Subject: Draft Response to U.S. EPR Design Certification Application RAI No. 448,
FSAR Ch. 3, Questions 03.08.01-50-55
Sent Date: 3/7/2011 10:53:03 AM
Received Date: 3/7/2011 10:53:27 AM
From: WELLS Russell (AREVA)

Request for Additional Information No. 448(4898, 5084), Revision 0

U. S. EPR Standard Design Certification

SRP Section: 03.08.01 - Concrete Containment

Figure 03.08.01-52-1—Coarse Slice Model Mesh Density (a) Typical RCB Section, (b) Typical RCB Dome, (c) Typical RCB Wall

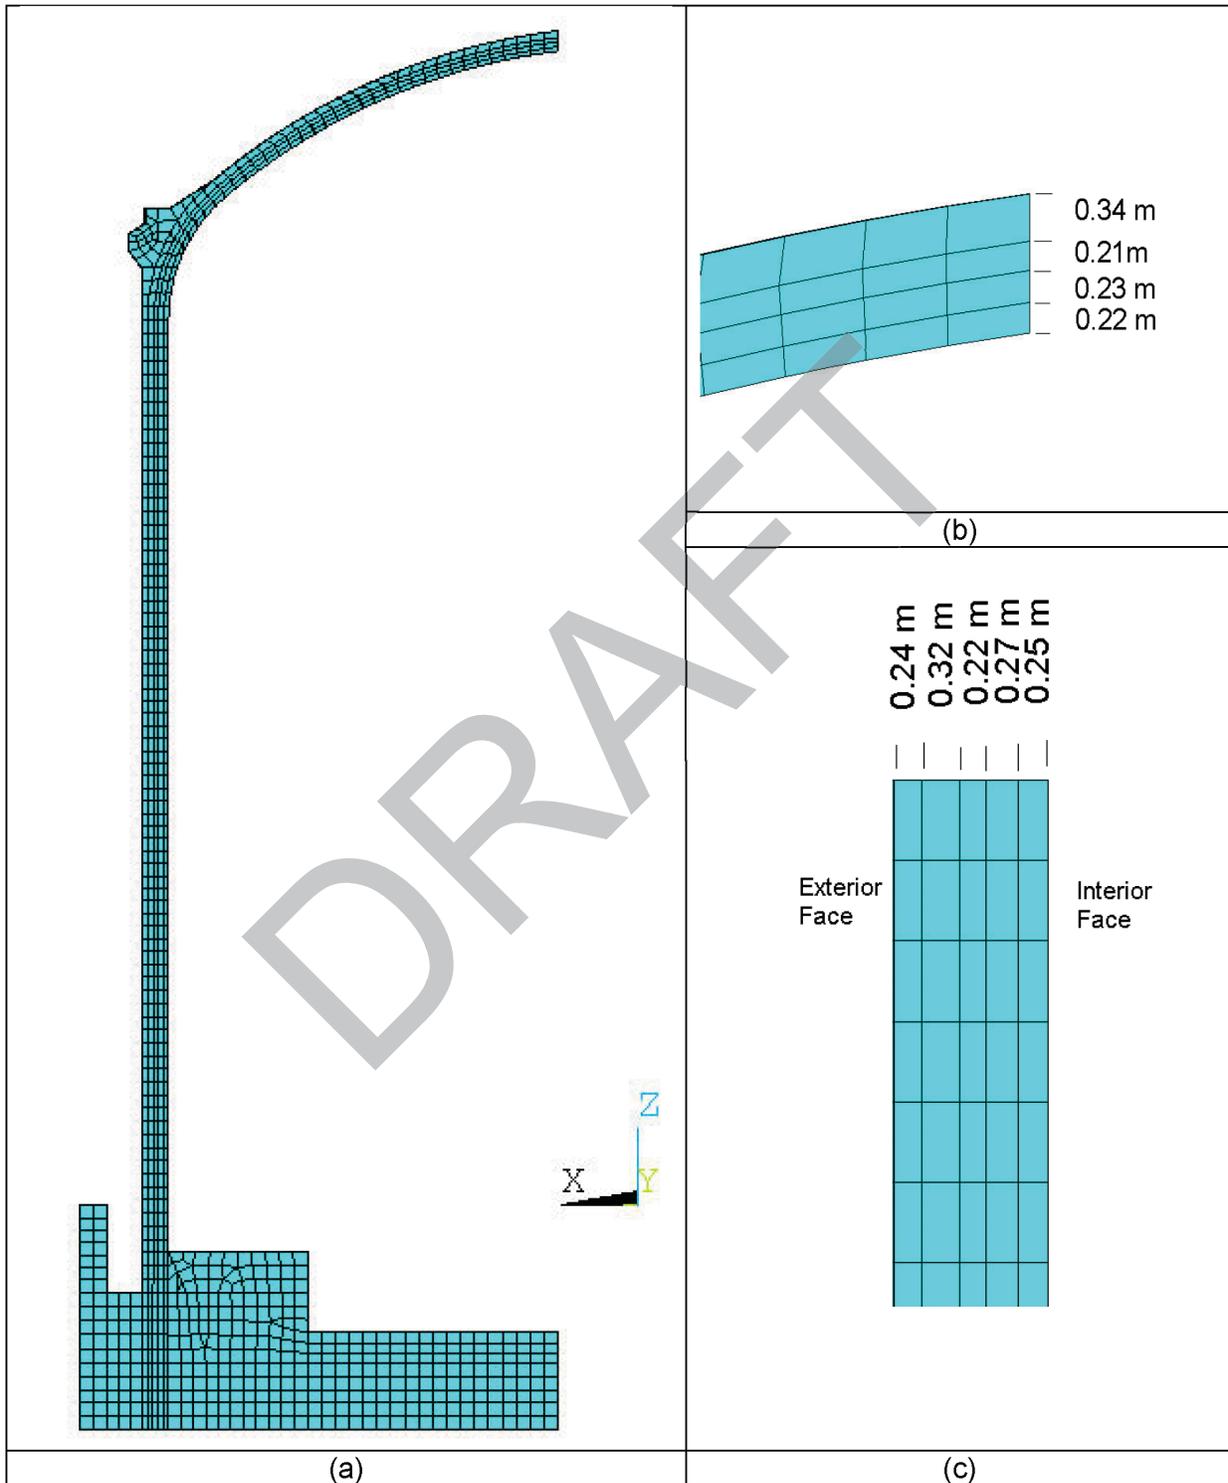
- a. The RAI response states that the mesh density in the 6-degree slice FEM model is increased to calculate the change in thermal moments due to mesh refinement. Provide a description of this mesh refinement, include a figure of each model, and identify the relative sizes of the original vs. the refined mesh.

- a. Item 1 of the RAI response indicates that a six degree slice of the containment is studied for mesh refinement in consideration with thermal moment calculations, presumably as described in the response to RAI 3.8.1-22. Based on this study, AREVA indicates that the existing 4/5 element mesh through the thickness of the RCB overestimates the thermal gradient across the thickness, at the beginning of the accident period, and provides an accurate estimate of the thermal gradient at the later period of the accident, compared to the thermal gradient for a refined mesh. To complete the response to Item 1 of the RAI, provide some representative (max., min.) comparison results determined in this study, for selected elements/regions of the RCB, such that the magnitude of the stated conservatism can be quantified. Since the computed thermal moments are subsequently reduced by “thermal moment reduction factors,” as explained in the response to RAI 3.8.1-22, confirm that this conservatism is actually eliminated from the forces/moments used in the RCB design. Information regarding this issue should be provided in conjunction with the response to the follow-up to RAI 3.8.1-22, Items 1 and 2.

The U.S. EPR thermal transient analysis considered six-degree slice finite element models (FEMs) with two mesh densities, which are an equivalent slice model mesh density and a refined slice model mesh density (refer the Response to RAI 155, Question 03.08.01-22). The equivalent slice model has similar element thickness and mesh density as the Reactor Containment Building (RCB), while the refined slice model has a refined mesh density. The mesh densities of the containment wall and dome equivalent and refined slice models are provided in Figures 03.08.01-52-1 and 03.08.01-52-2, where the element thickness is shown between the hash-marks. The variation in temperatures through the thickness of the containment wall (at 65.86 feet) and dome (75 degrees from horizontal) at different time points
